BOUNDARY SURVEY

NAME OF PLAT: Linson Homestead DATE REVIEWED: February 28, 2022 REVISED REVIEWED BY: Randall L. Roberts, RLS

177.041 - Boundary Survey and Title Certification Required

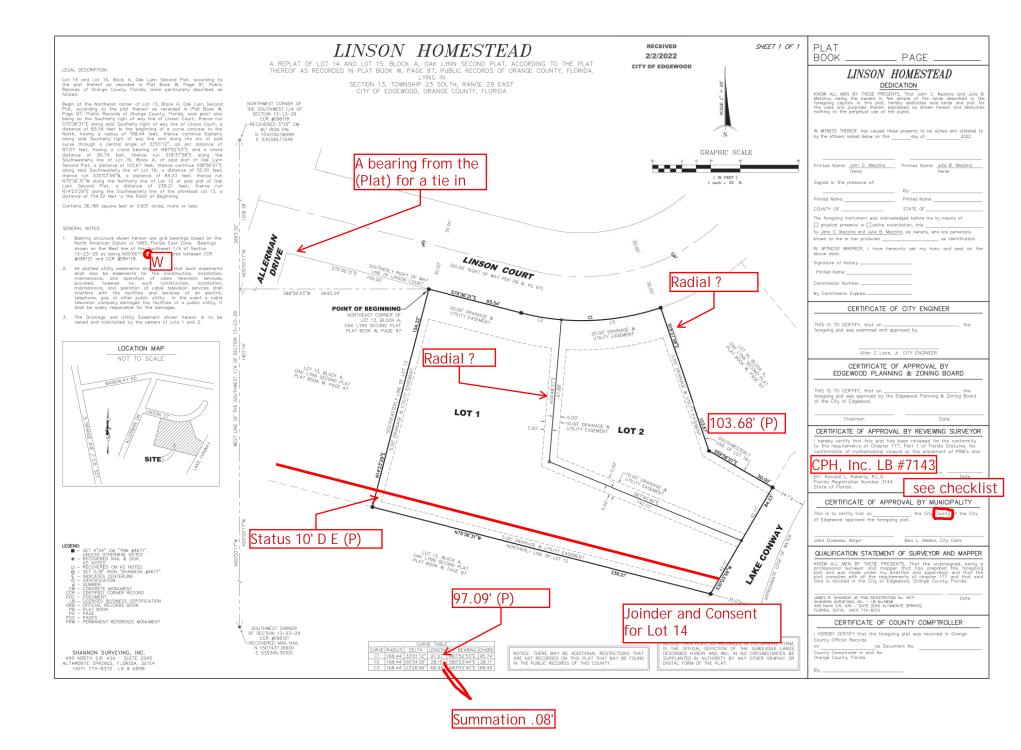
add title information dated Feb 24, 2022
